ISSUE: Permit to Demolish/Capsulate (partial) and Certificate of Appropriateness for alterations and addition

APPLICANT: Metro Fine Properties, LLC

LOCATION: Parker-Gray District
328 North Patrick Street

BAR #2019-0146 & BAR #2019-0147
328 North Patrick Street

0001-AD=AD1
FIRST FLOOR DEMOLITION PLAN
328 N. PATRICK STREET
JOB # 19-118
APRIL 2019

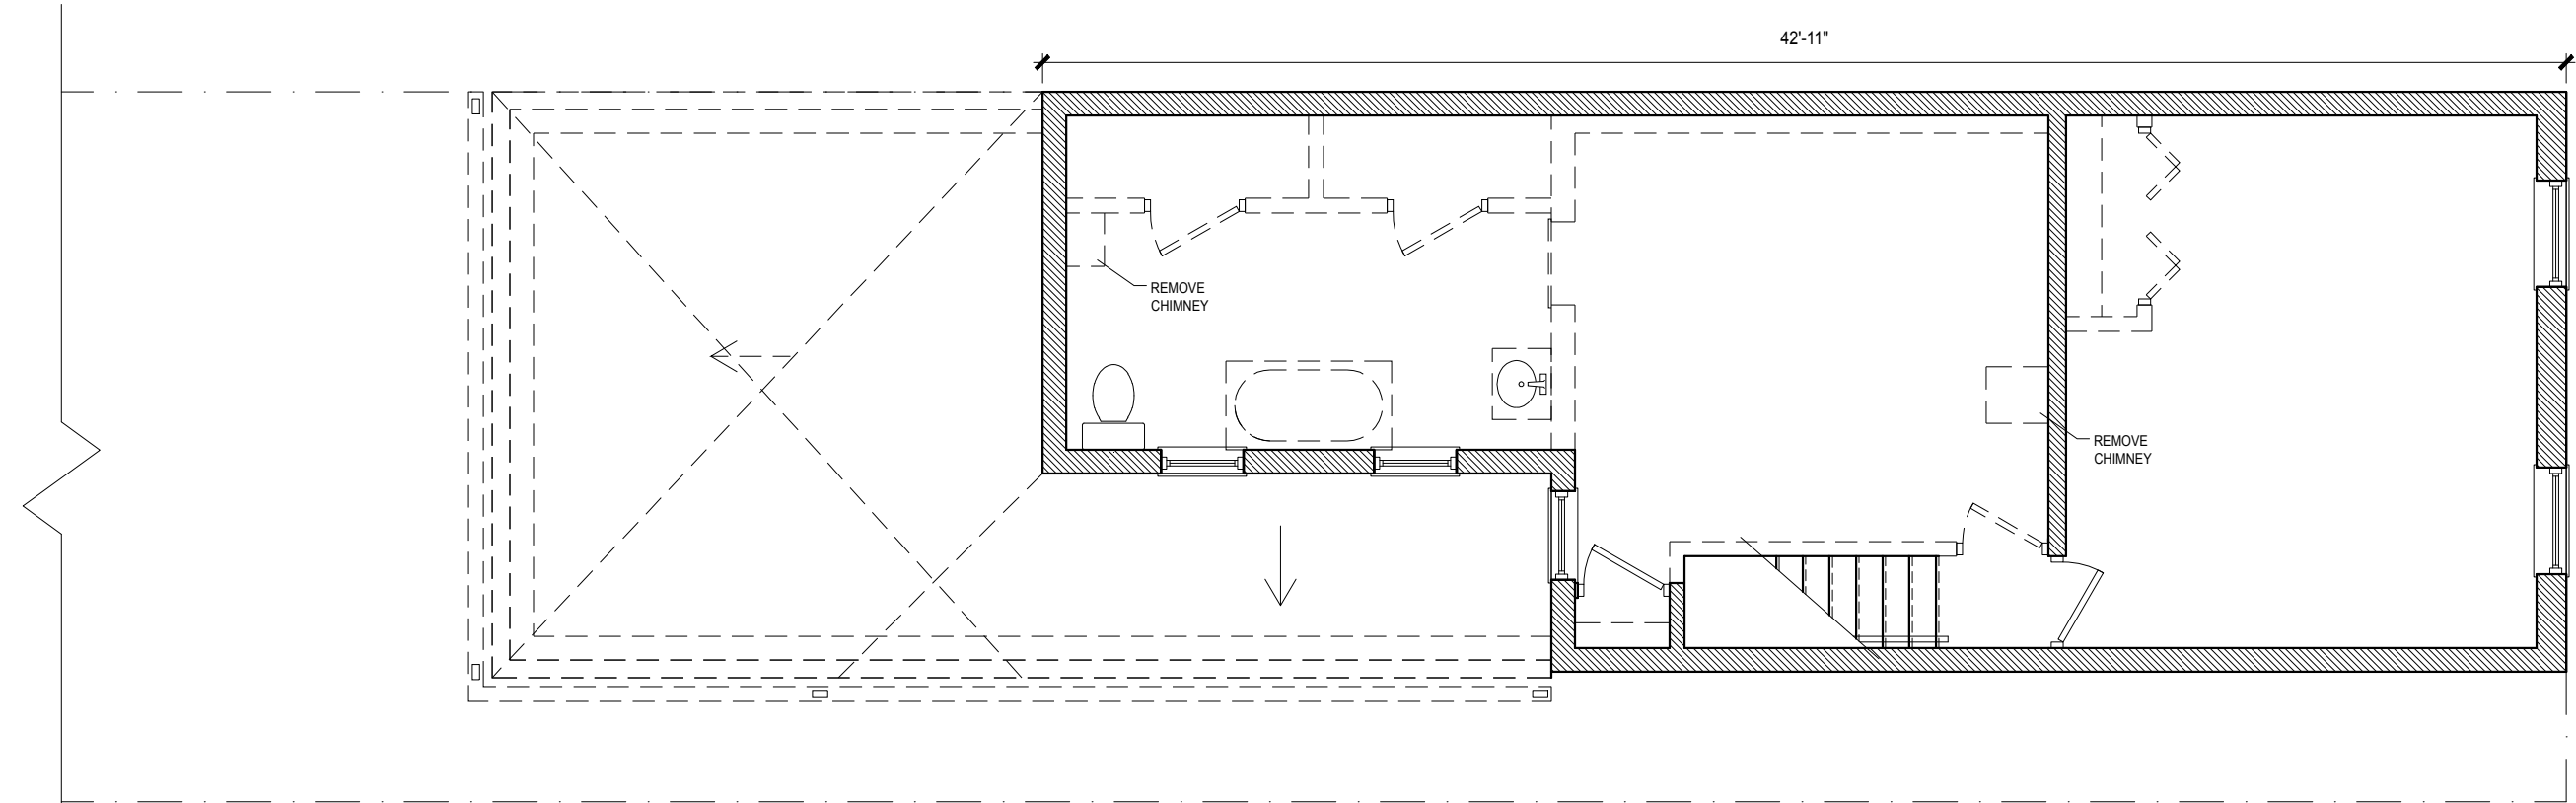
Staff has no objection to the total demolition of the later one-story frame addition at the rear. While no building permits for this addition could be located, it is clearly not original to the building and it has no historic or architectural significance. Staff also has no objection to the demolition of the first floor of the south elevation of the ell because the overall form of the primary building mass-and-ell will still be legible at the roof and second floor wall. The Board routinely approves small changes on the rear elevations of historic buildings to accommodate a more modern and functional interior layout as tastes and technology evolve. The existing rear elevation does not exhibit a high level of design or architectural detail and uses materials that could be reproduced easily.

Staff does not support the demolition of the woodburning fireplace chimney on the front gable since it is a historic feature of the building. The *Design Guidelines* state that "...existing chimneys should be maintained *in situ* and not removed without a compelling reason and substantial justification." The Board has objected to the demolition of prominent brick chimneys of woodburning fireplaces in the past, as was the case at 515 South Fairfax Street (BAR Case #2018-00528). However, the Board has routinely approved the removal of small utilitarian chimneys/flues in the rear to accommodate a more functional interior layout. Therefore, staff recommends denial of the demolition of the woodburning fireplace chimney in the mid-section of the main building but supports the removal of the utilitarian chimney at the rear portion of the ell.

Thus, staff recommends the Permit to Demolish/Capsulate be granted with the condition that the woodburning fireplace chimney is preserved.

SIDE DEMOLITION ELEVATION

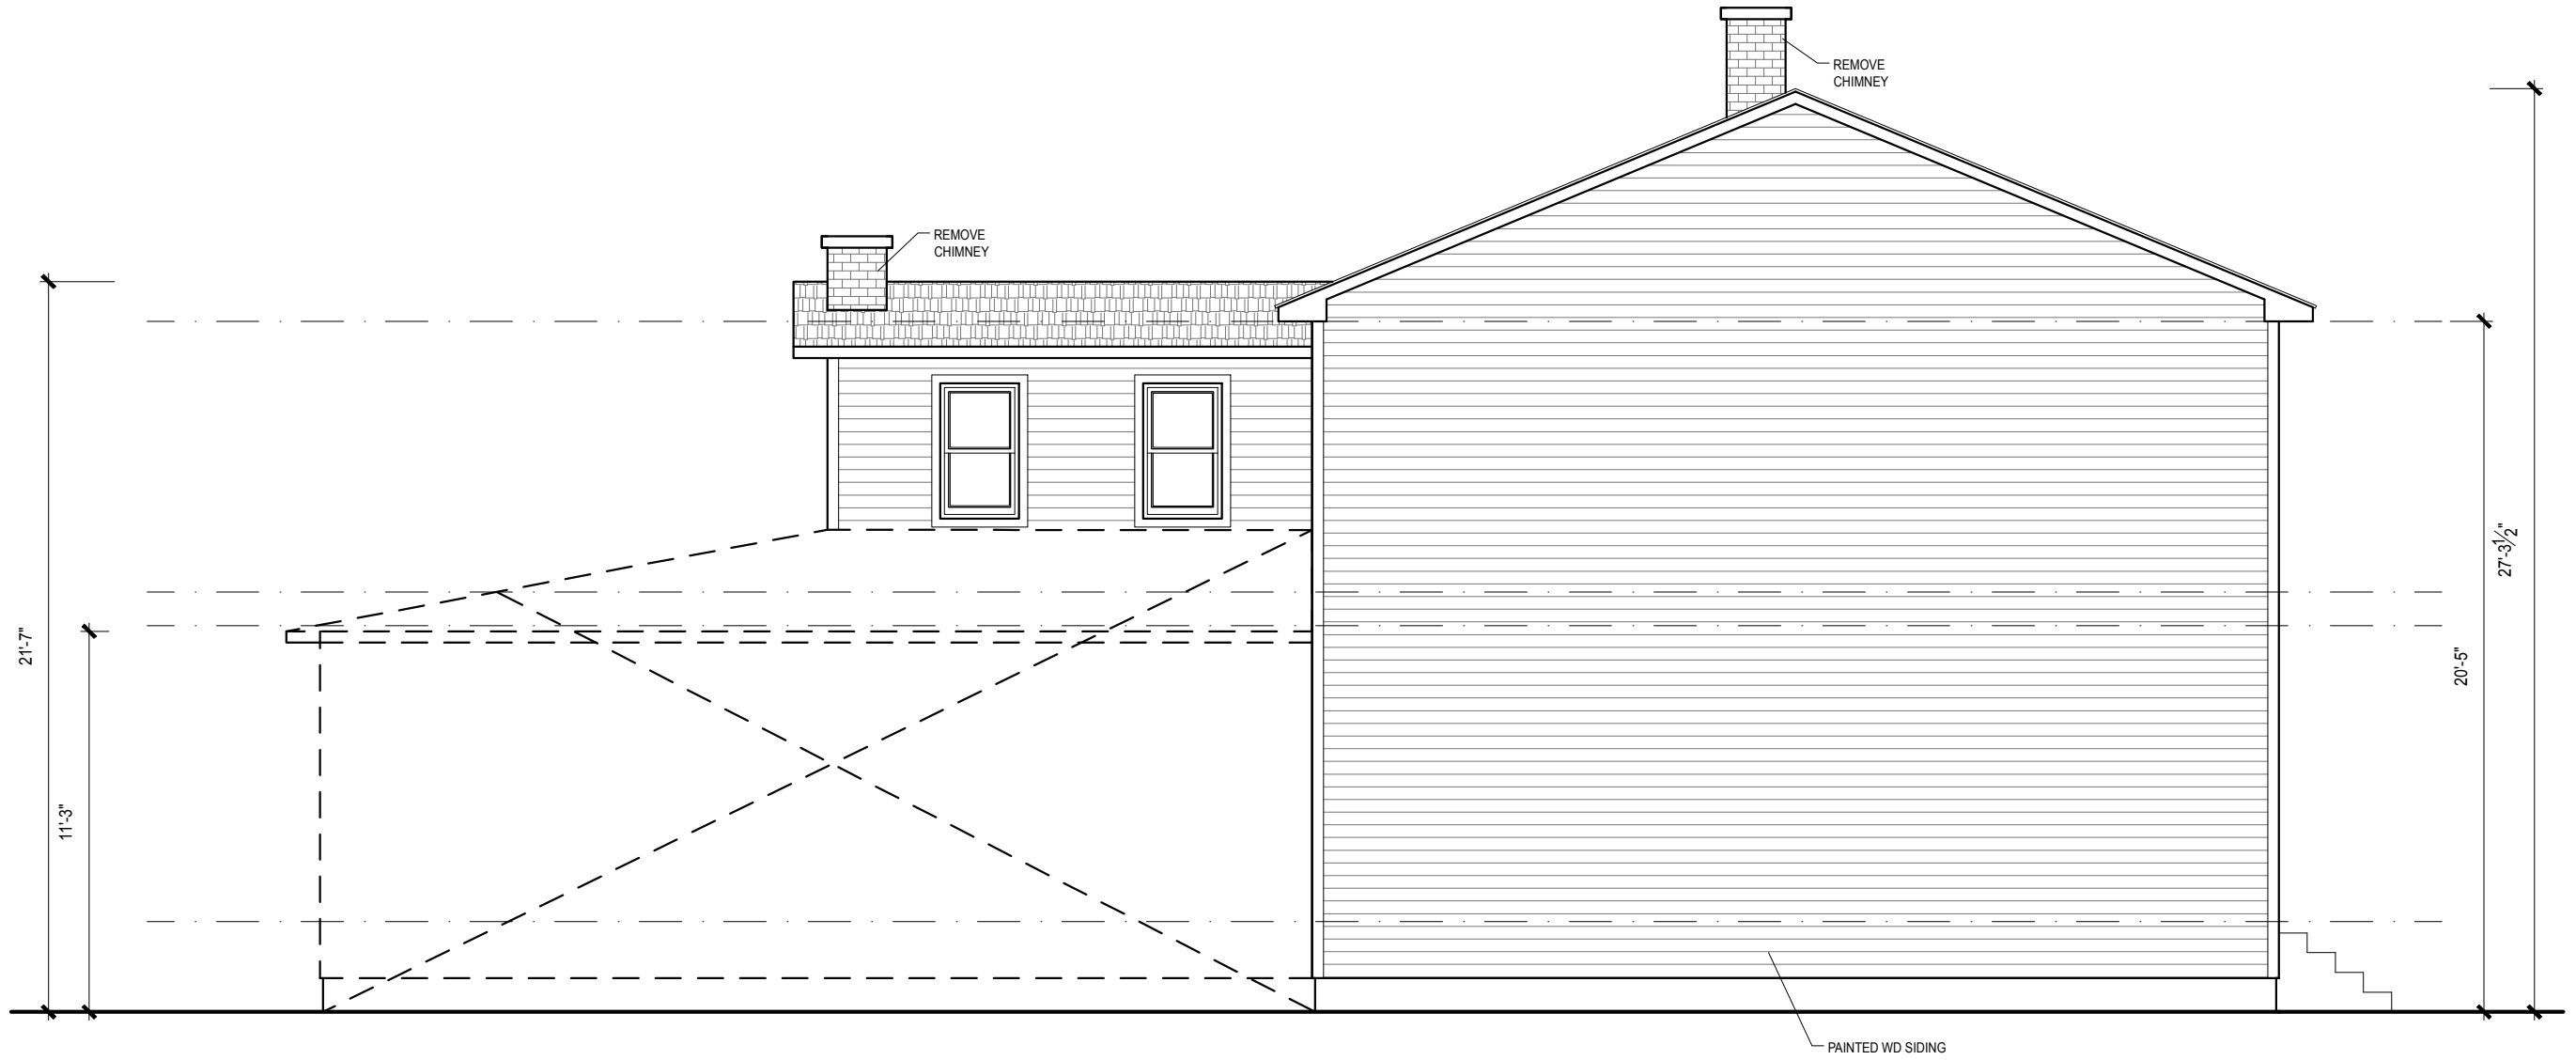
4. The one-story addition on the south elevation below the second floor of the historic ell should be set back at least 6 inches from the wall plane of the historic house to differentiate between the historic house and new construction and to reflect historic patterns of development for a service ell attached to the primary structure;

Setbacks are another way to help differentiate new construction from historic buildings and instead of constructing the one-story portion of the addition in the same plane as the south wall of the historic main block, staff recommends that the south elevation of the new one-story addition be set back at least six inches from the historic house to emphasize the original building ell configuration and traditional development patterns. At a minimum, there should be vertical trim boards extending down the first floor wall from either side of the second floor recess on the south elevation. This will also provide a place on the south wall to terminate existing wood and begin synthetic siding.

11 Each FD5684 SWD3360

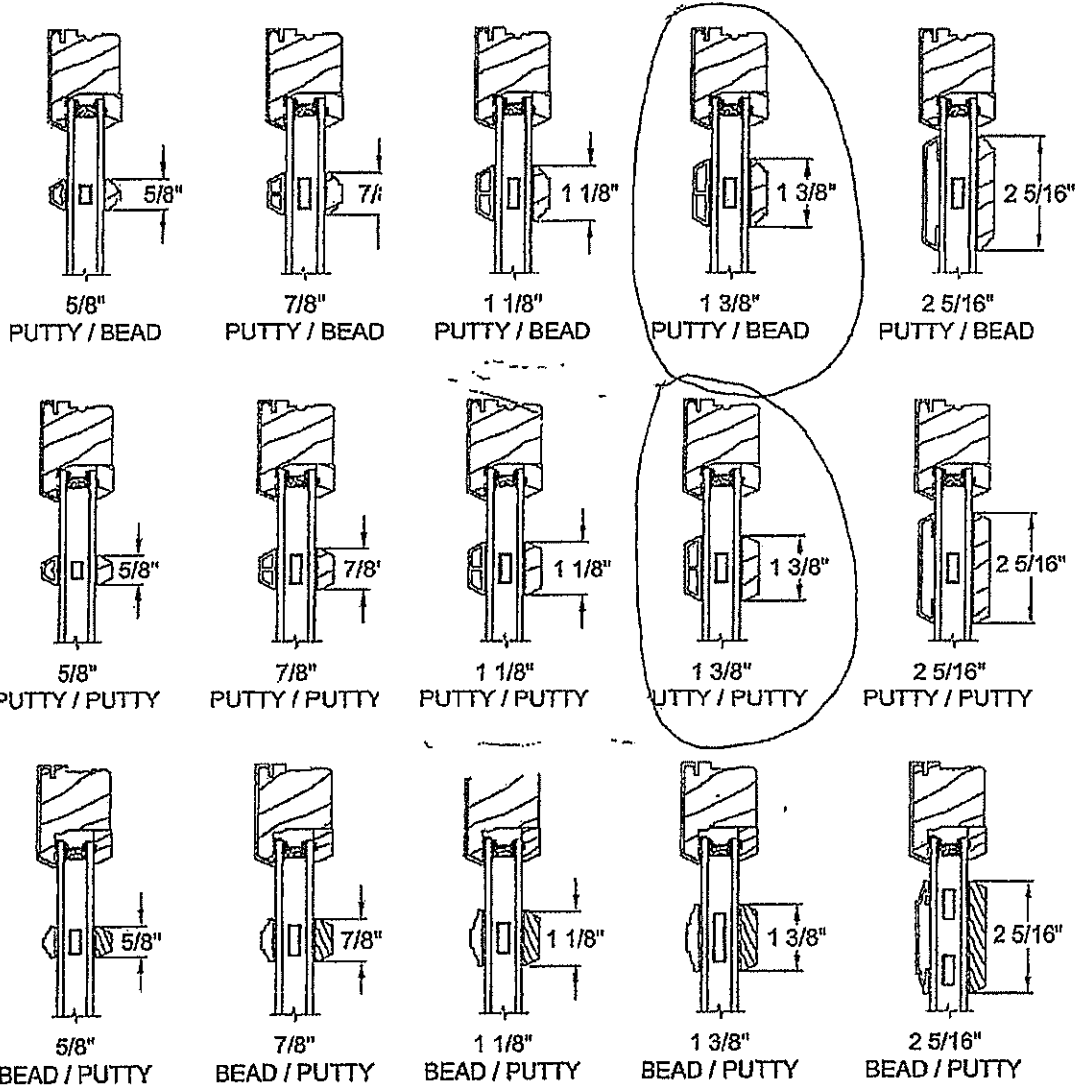
3. The windows should be aluminum clad or fiberglass in a one-over-one configuration on the addition, and must comply with the Boards *Alexandria New and Replacement Window Performance Specifications in the Historic Districts*;

7. The windows on the main historic building's street-facing façade must be made of wood and have a six-over-six light configuration and comply with the *Alexandria New and Replacement Window Performance Specifications in the Historic Districts* unless otherwise specifically stated at the hearing; and,

The applicant is proposing to remove the existing one-over-one windows on the main building and replace them with two-over-two windows to match the windows on the proposed addition. The *Guidelines* states that: “Changes to windows can have a dramatic impact on the historic appearance of a structure. Many buildings in the historic districts have had the windows changed in an attempt to alter the historic period of the structure or to create the appearance of modernity.” Furthermore, “New and replacement windows and doors should be appropriate to the historic period of the architectural style of the building.”

Staff does not support the two-over-two light configuration anywhere on this structure, since this light pattern is characteristically late-Victorian and would not be appropriate for this early vernacular building with a side gable roof. In Alexandria, windows on frame vernacular buildings of the mid-19th century and those with gable roofs typically had a six-over-six light configuration which staff recommends in this case for the street-facing (east) façade and the second floor of the historic ell. Windows on the addition sections should be something slightly more modern, to clarify that this is a modern addition, and staff recommends one-over-one windows for the addition. The Parker-Gray Window Guidelines recommends that windows on the street facing façade be wood, while windows on non-street facing elevations be any material but vinyl, with no sandwich muntins, and must match historic operation and light configuration with no tinted or reflective glass.

Door	
Product Use	EXTERIOR
Model	C44
Specie	FIR
Wood Treatment	NONE
Finish	NATURAL
Woodcore	JOINTED
Bevel door	NONE
Slat Model	NA
Prefit	0.00
Trim	0.00

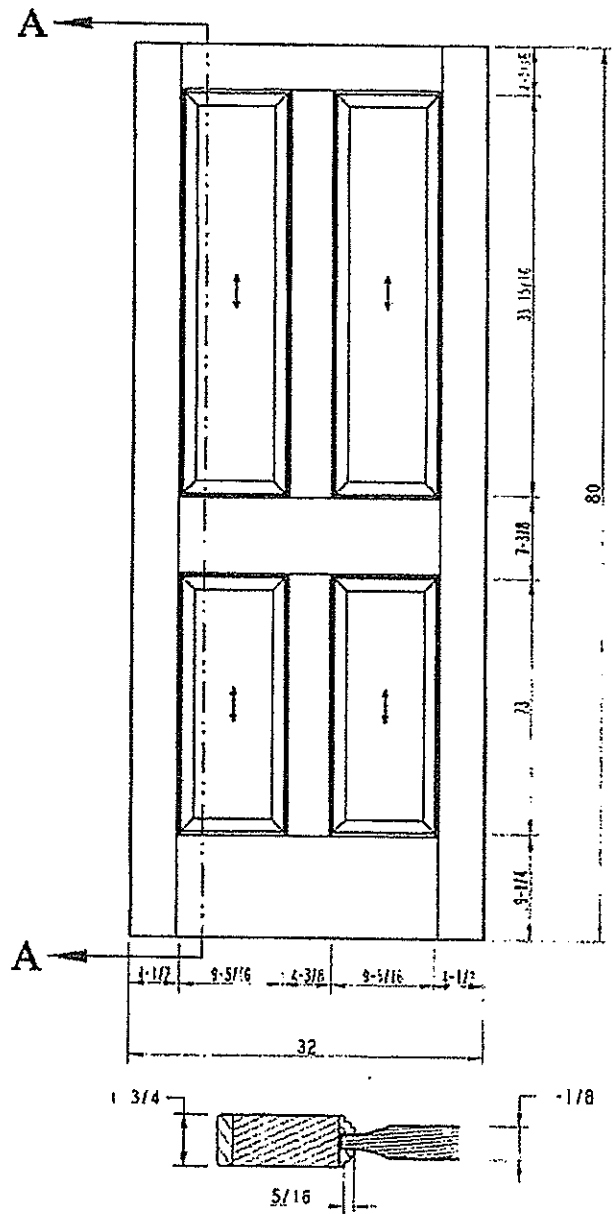
8. The front door on the street-facing (east) elevation must be painted wood with six panels or be a historically appropriate mid-19th century vernacular design approved by staff.

Likewise, staff does not support the proposed four panel front door, as this is not stylistically appropriate for the mid-19th century, but rather recommends a traditional six-panel, painted wood door, or another historically appropriate design from that period. The door on the south side does not face the street and is not subject to review by the BAR in Parker-Gray.
